Appendix A7

Design Refinement

Document no.	Appendix A7
Project/s	NISA (North Irish Sea Array) – North Irish Sea Array
Originator Company	NISA Windfarm Ltd
Document Type	PN- Plan, Management Plan, Inspection & Test Plan
Package	ENV - Environmental
Revision	02
Classification	Public
Date	22/05/2026

Image A2.1: Refinement of WTG Layout Options for Project Option 1

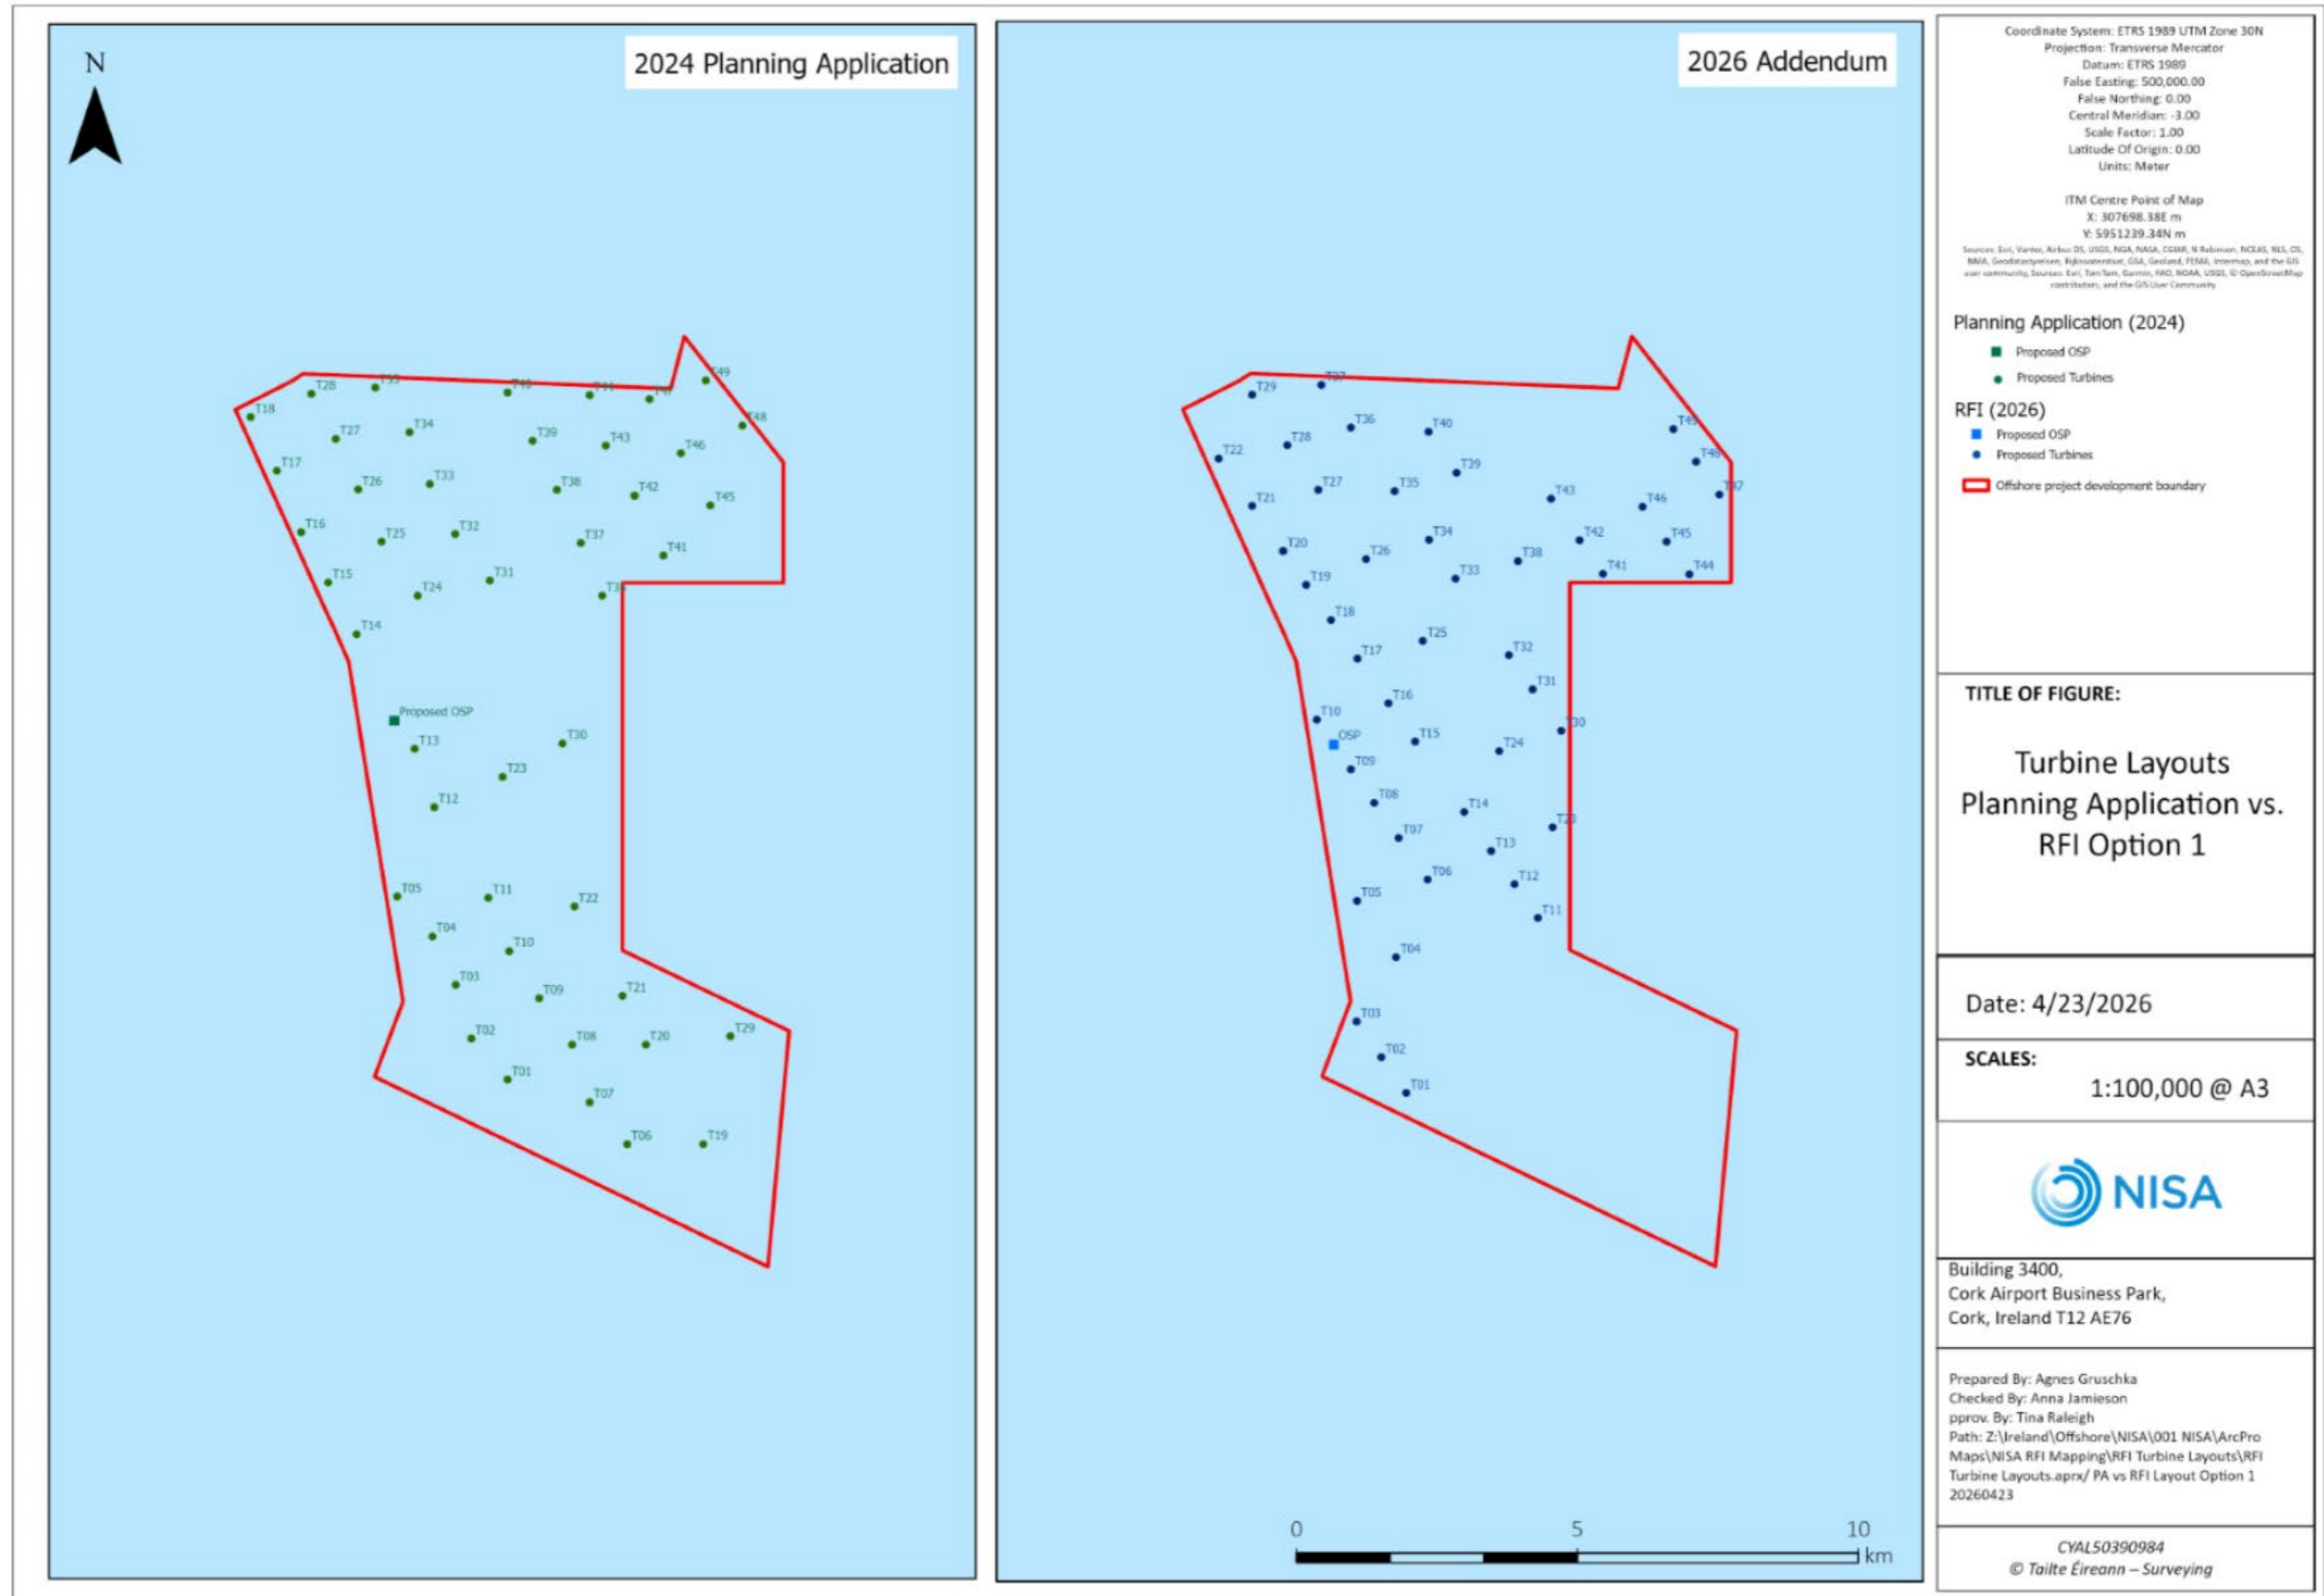
1. Refinement of WTG layouts for Project Option 1 and Project Option 2 (Images A2.1 and A2.2), to address stakeholder (IRCG and MSO) concerns around navigational safety and offshore infrastructure footprint;

- 2a - IRCG raised concerns in relation to the layout of the proposed development with respect to search-and-rescue (SAR) access. This has been addressed and accepted by IRCG by updating WTG layouts for Project Option 1 and Project Option 2.

- 2b - the Marine Survey Office (MSO) disagreed with the summarisation of the risk to the safety of navigation posed to commercial shipping, fishing vessels, and recreational craft transiting in proximity to the southeastern corner and the Rockabill GAP. This has been addressed and accepted by MSO by updating the WTG layouts for Project Option 1 and Project Option 2, to increase the Rockabill GAP and to reduce the infrastructure in the south east corner.

Image A2.3: Jacket foundation on suction buckets and jacket foundation on pin piles

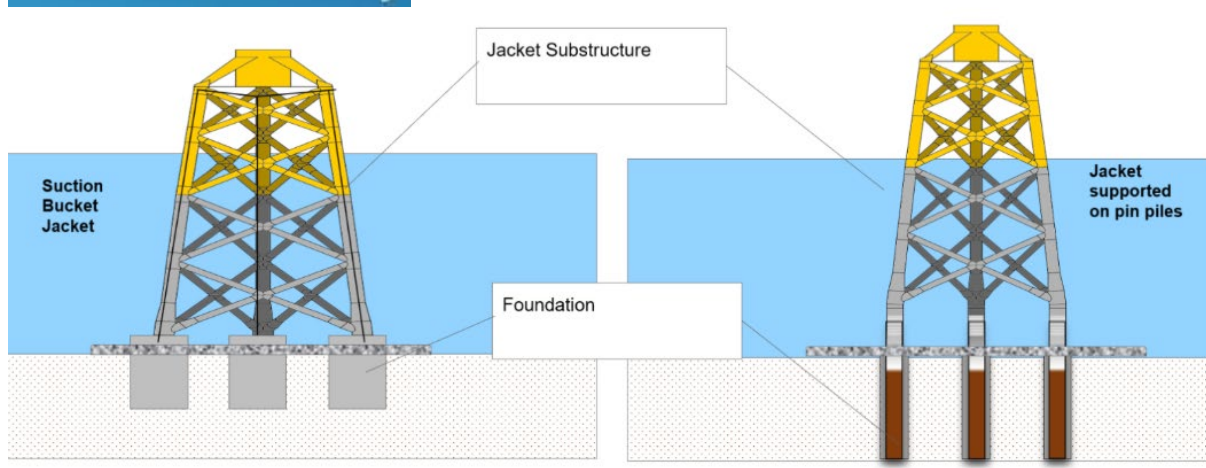
2. Removal of both driven and drilled monopile foundations and jackets with pin pile foundations as options for WTG installation from Project Option 1 and Project Option 2, and a refinement to the WTG foundation installation methodology to jackets with suction buckets (hereafter referred to as 'SBJs') for Project Option 1 and Project Option 2³ to address key stakeholder (NPWS) concerns in the RFI around underwater noise. Suction buckets are a low underwater noise solution⁴ for WTG installation and a proven technology on other wind farms⁵ (See image A2.3 for details of suction bucket technology);

3. Removal of monopile foundations for the Offshore Substation Platform (OSP), and refinement of the OSP foundation installation to SBJs or jackets with drilled pin piles, which significantly reduces potential underwater noise effects during construction from piling activities and responds to key concerns from NPWS on this matter within the RFI; and
